Sunol Tree Gas Station Fuel Release
3004 Andrade Road, Sunol

SITE CONCEPTUAL MODEL

23027

June 2004

<p>SITE PLAN AND PROPOSED WELL LOCATIONS Sunol Tree Gas Service Station 3004 Andrade Road Sunol, CA 94586</p>	CLEARWATER GROUP		
	Project No. CB021C	Figure Date 5/03	Figure 2

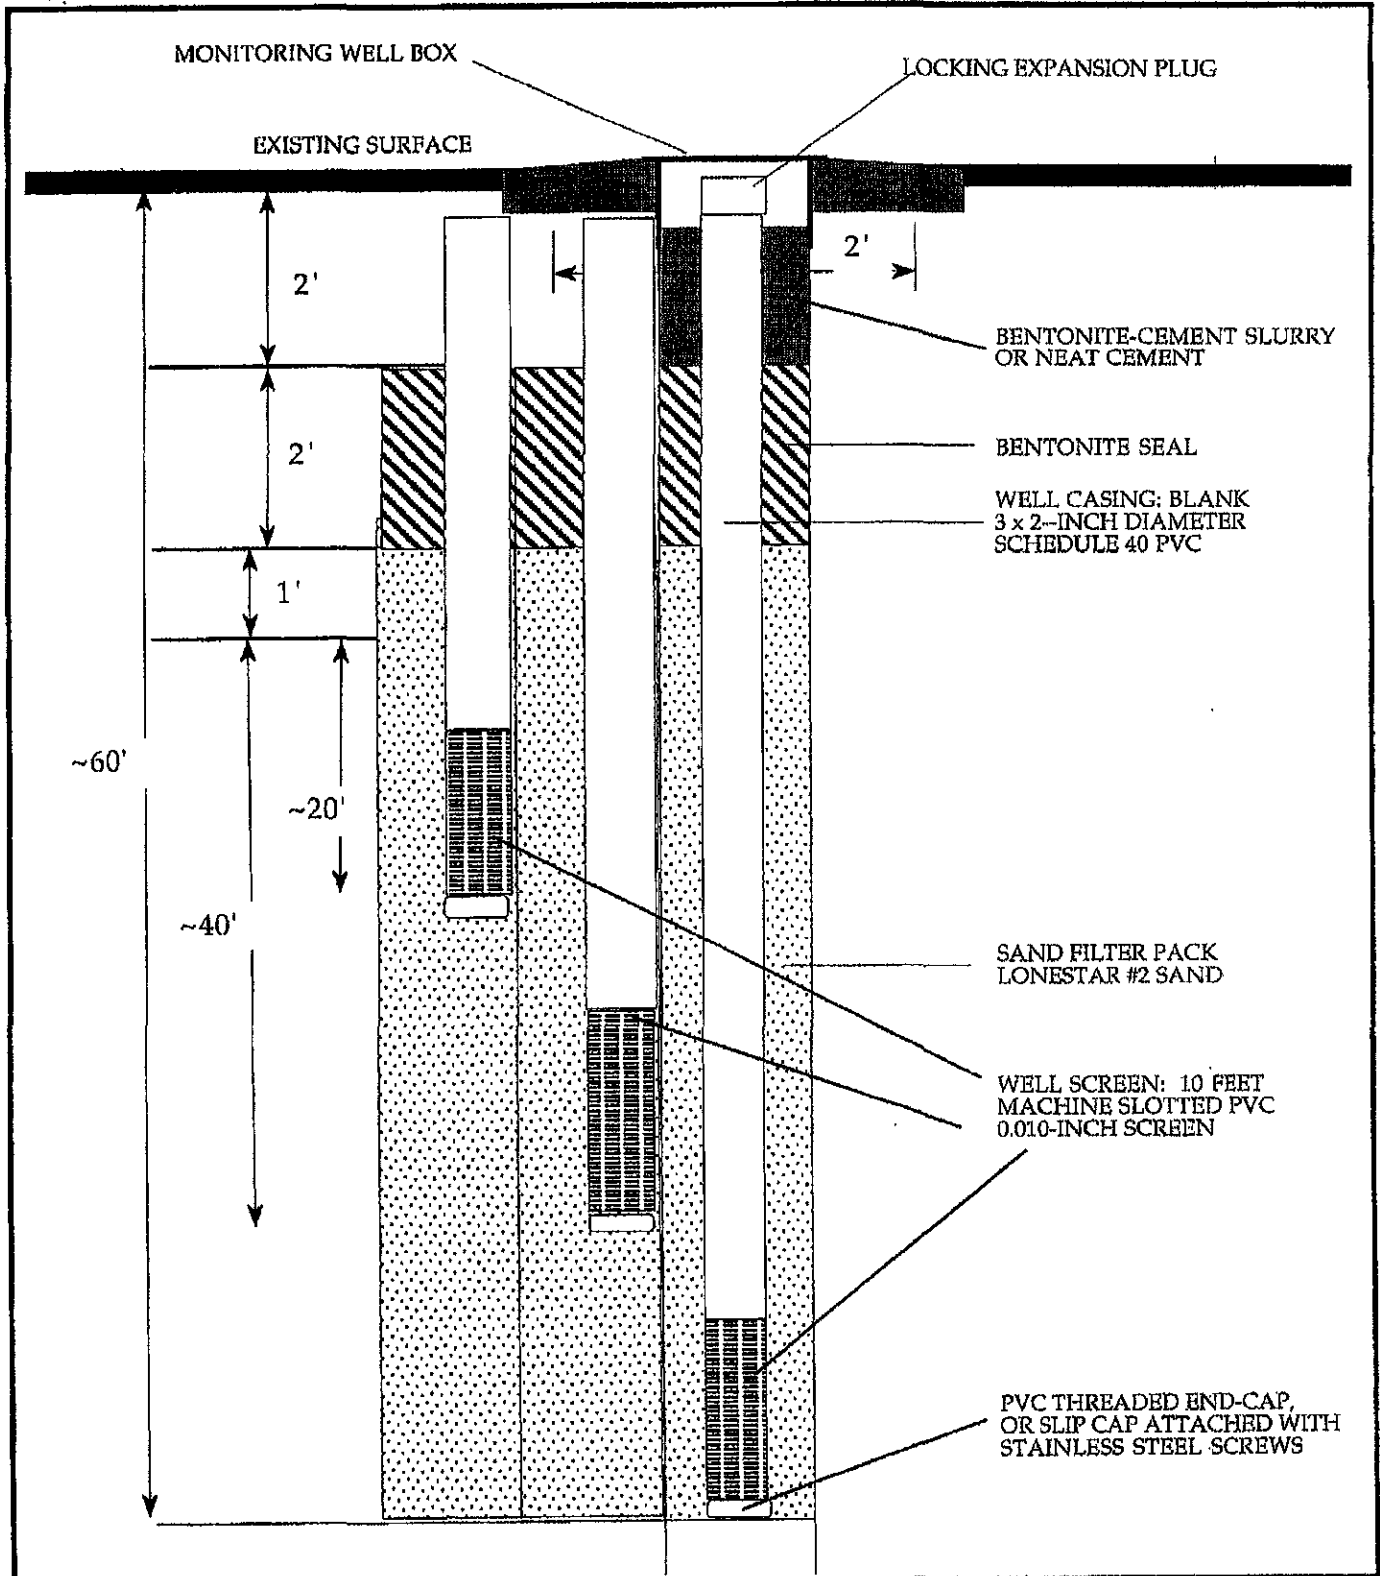
2) **Transect of Monitoring Wells** – The work plan proposes to place a transect of wells in the same location as the temporary piezometers. These locations do not correspond to a transect oriented perpendicular to the expected axis of the contaminant plume as was requested. The temporary piezometers are intended to determine groundwater flow direction so that the transect can be oriented appropriately. Clearwater's proposal appears to ignore that intent.
